**RE: River's Peak – Cabernet Builders**  
Boulder Drive, Barrington – Tax Map 215, Lot 1

We are in receipt of a review letter from DuBois & King dated April 18, 2014, concerning the above referenced project and have addressed the comments below.

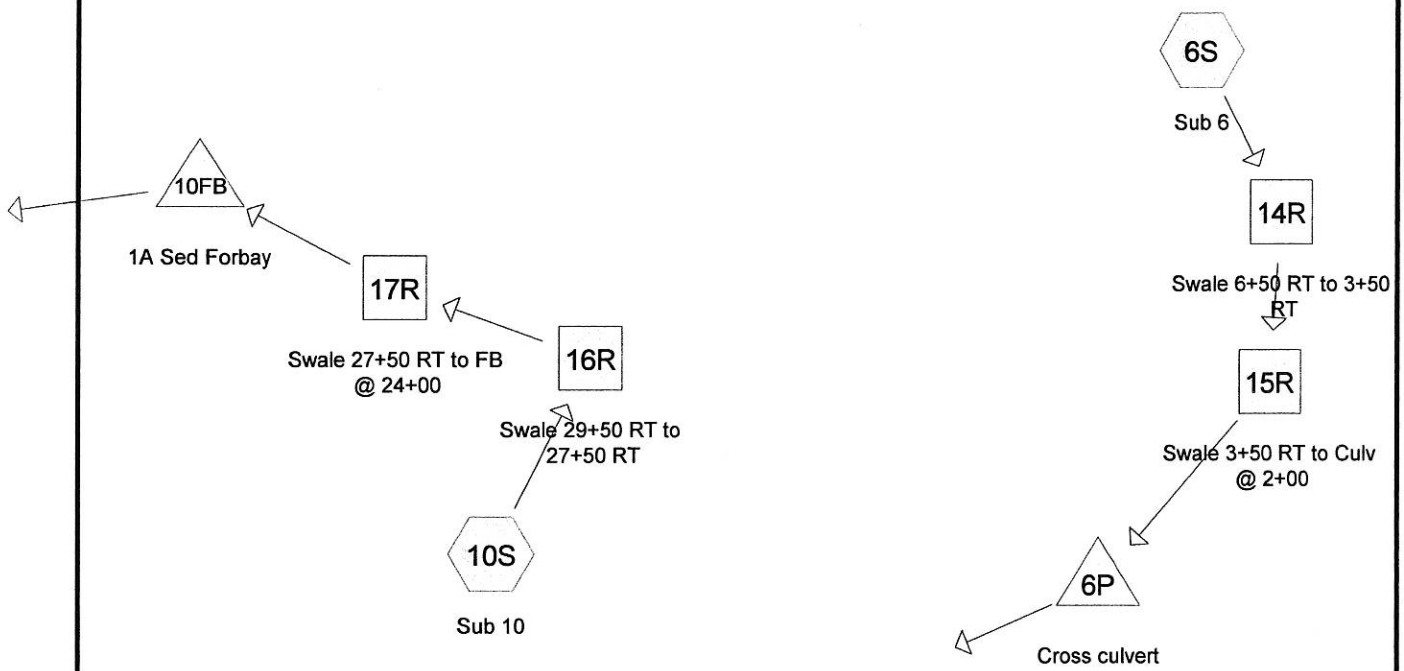
4. **RESPONSE:** The worst case scenario (e.g. the interior of the cul-de-sac draining entirely to the road side swale - Subcat #10) has been modeled and as can be reviewed in the attached partial HydroCAD report the 50-year storm event the average depth at peak storage within the 2' deep swale is 0.86'.

5. **RESPONSE:** The swale has been modeled dynamically and the shallower section shows a depth at peak storage of 0.45' under a 50-year event.
6. **RESPONSE:** Pipe materials have been clarified in the gravel wetland detail as requested.
